SFF-TA-8613

Mini Multilane 4/8X Unshielded Cage/ Connector (HDun)

Rev 3.5.54 ~~January 18, 2021~~ May 8, 2026

5 **Figure 4-2 Contact Numbering**

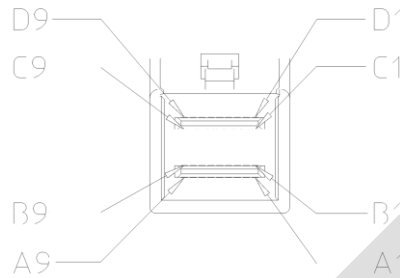
2 The pins or electrical contacts in this connector are numbered as shown in Figure 4-2. Press-fit tails shown for
3 reference illustration purposes only and dependent upon footprint type.
4

Figure 5-9 Receptacle Blocking Key

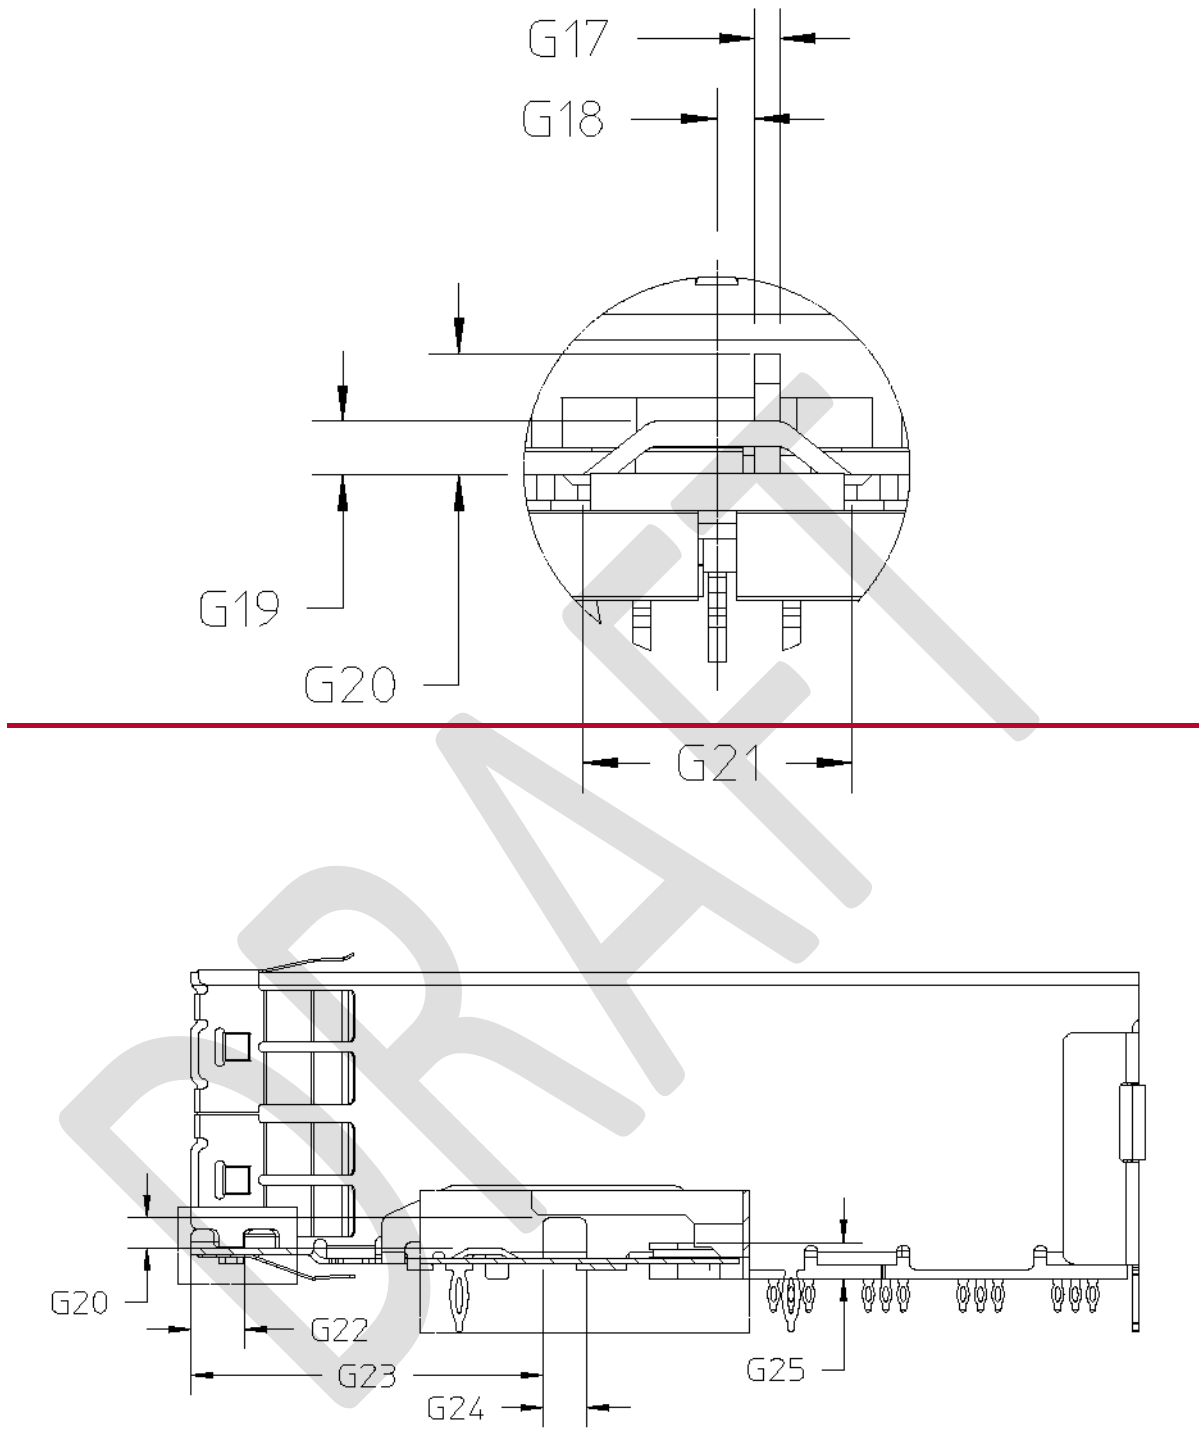
- Updated Boilerplate
- Section 4.2: Added note for press-fit tails.
- Table 5-1: Added new Datums
- Table 5-3: Removed VT
- Figure 5-9 and Table 5-5: Removed.
- Section 5.6: Revert from Press-Fit to Through Hole
- Section 5.6.2: Regenerated all drawings with new measurements and adjusted Table 5-9 to match.
- Section 7: Edits to clean up certain portions of this section.

Figure 5-1011 1x1 Right-angle Press-Fit Through Hole Receptacle Footprint Option

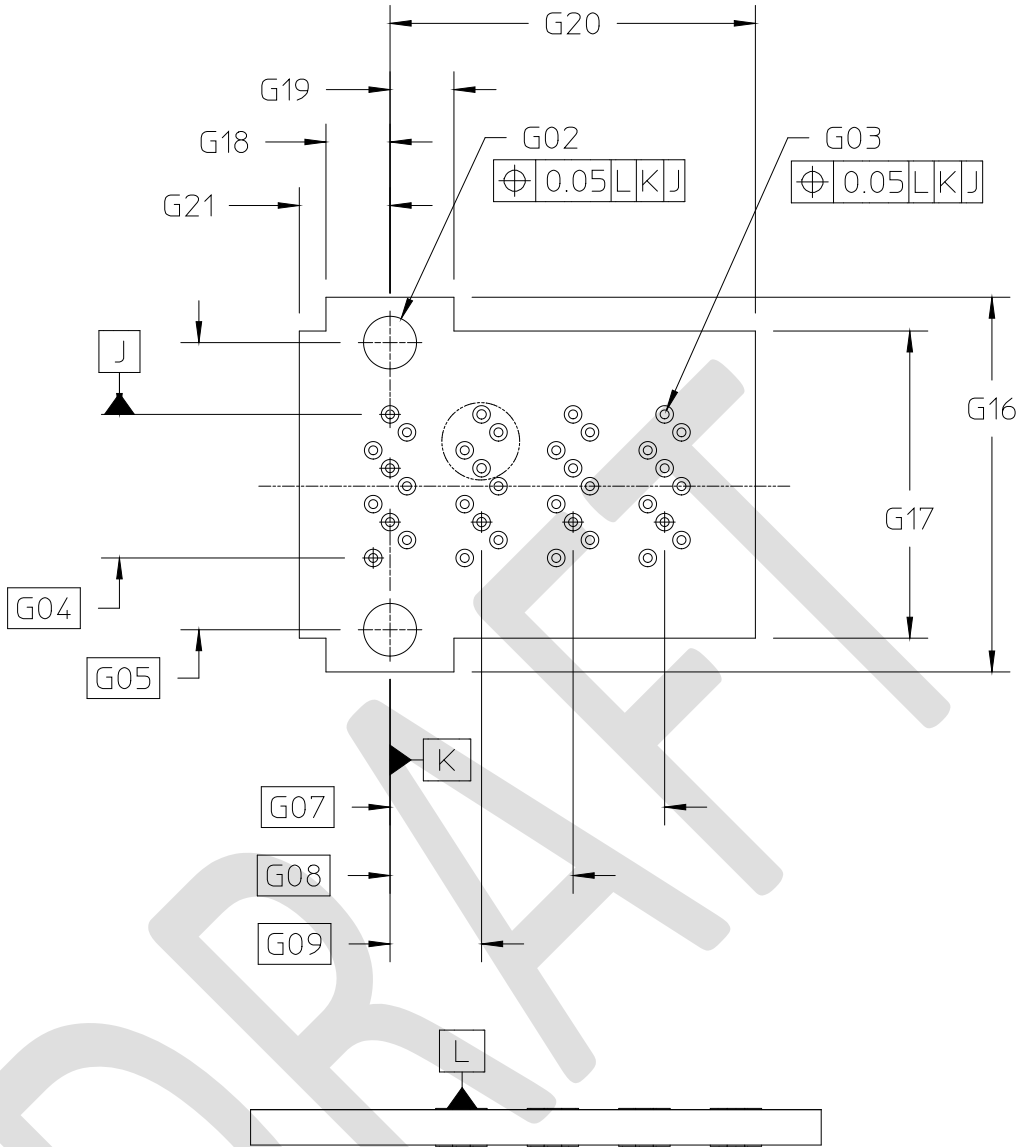
5.6.1 Press-Fit Through Hole Option
